Review of manuscript “Characterizing Thermodynamic Observations from Unshielded Multicopter Drone Sensors” by S. W. Freeman

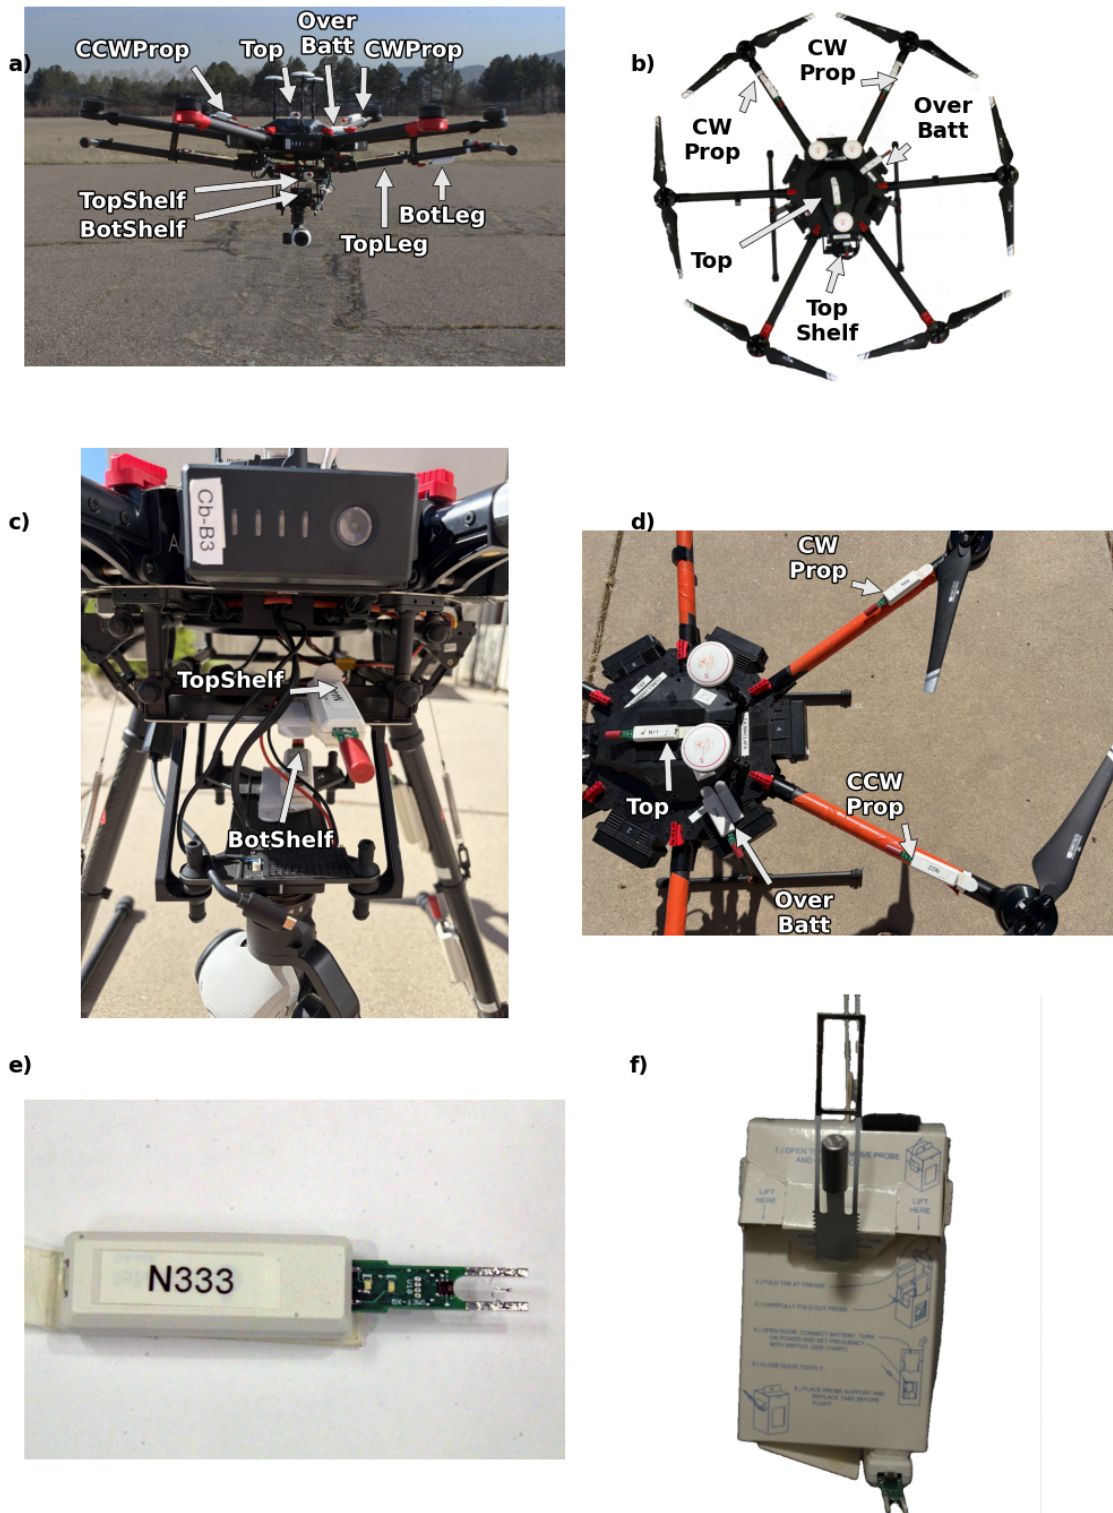
Line 88–90: In panels (a) and (d) of Figure 1, it is difficult to distinguish the UAS and sensor, respectively, from the background in the photograph. I recommend including a better photograph in both of these instances to enhance legibility.

Thank you for your comment. We have changed these photographs by removing or dimming the background to emphasize the UAS and sensors. We have also added two additional photographs of the UAS in the new Figure 1 panels (c) and (d), and have labeled the visible sensors, to show the sensor placement from additional perspectives. The new Figure 1 and its associated caption are repeated below:

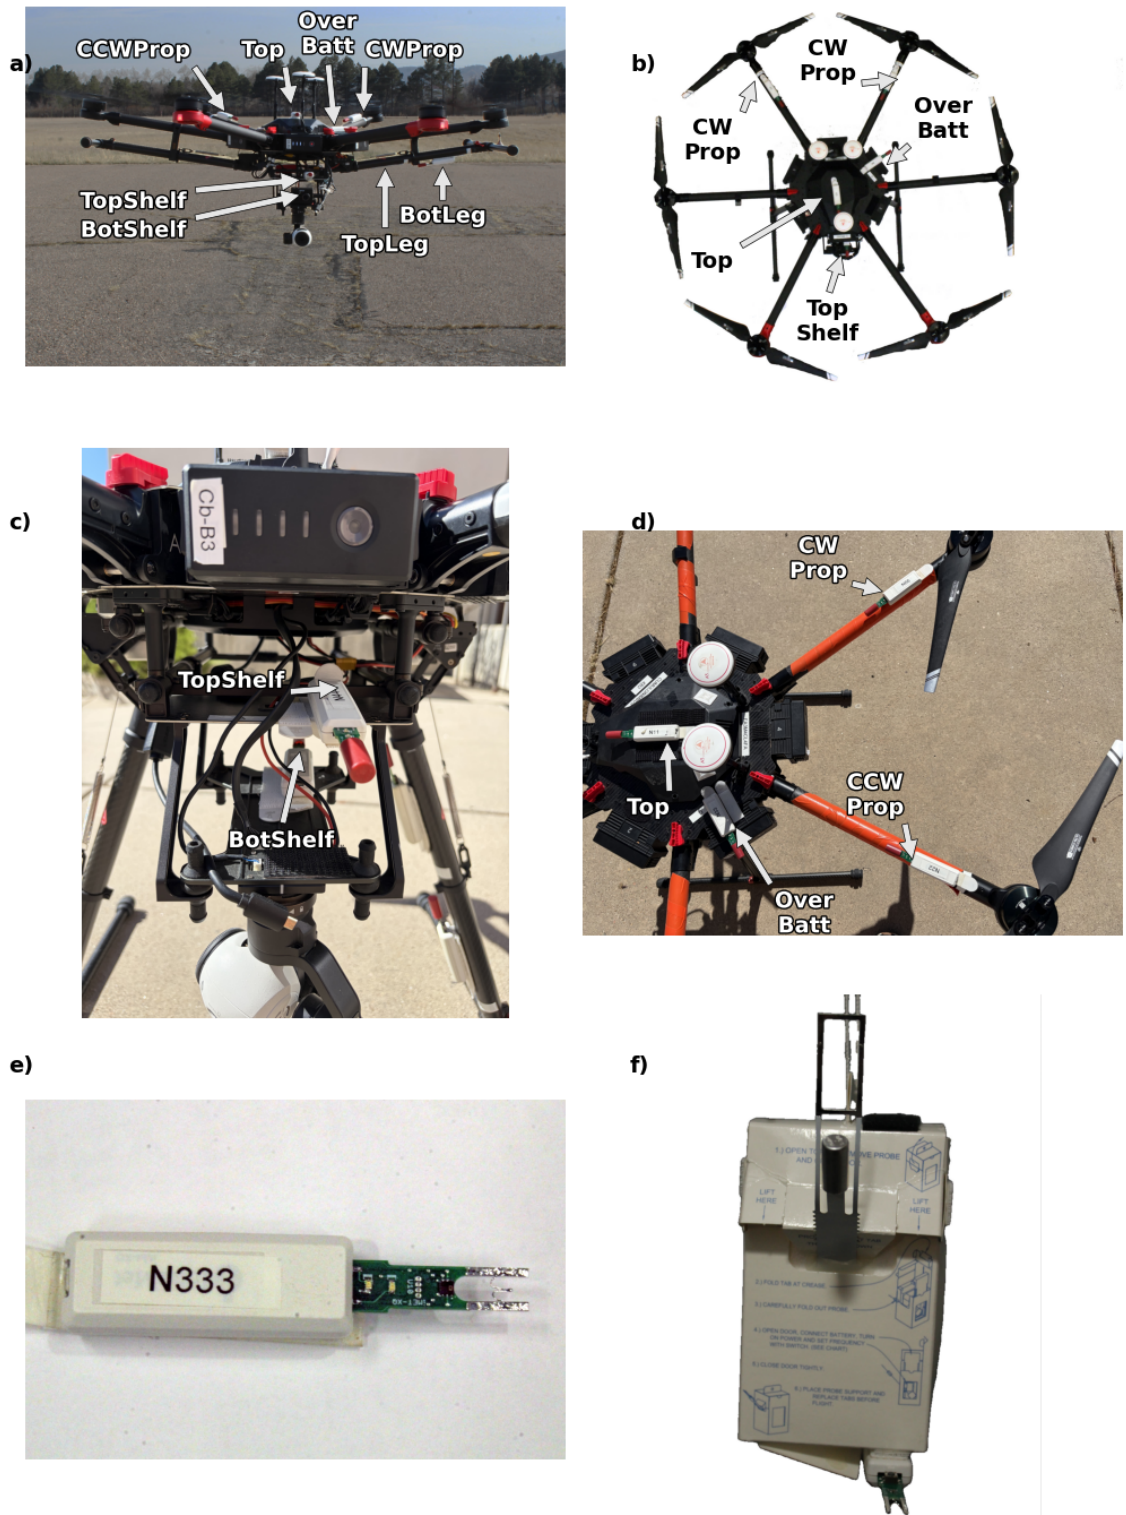
Close-up pictures of the various sensor locations on the drone would be helpful. The relative locations of the sensors are shown in Figure 1, but the specifics of how the sensors are mounted and where they are positioned relative to the support structures on the drone are unclear. E.g. TopShelf and BotShelf are on platforms mounted below the main electronics (lines 123 and 124). What do these platforms look like and where are they relative to the body of the drone? Is there any chance of shading by the drone parts?

We have made two changes to Figure 1, both in response to this reviewer's comment and to a comment from Reviewer 1. First, we have darkened the background of Figure 1a to help indicate the locations of the sensors relative to the drone. Second, we have added two additional photographs of the drone in the new Figure 1 panels (c) and (d), and have labeled the visible sensors, to show the sensor placement from more perspectives. Specifically, panel (c) shows the TopShelf and BotsShelf sensor mount locations. The new Figure 1 and its associated caption are repeated below. As for shading, we address this below.
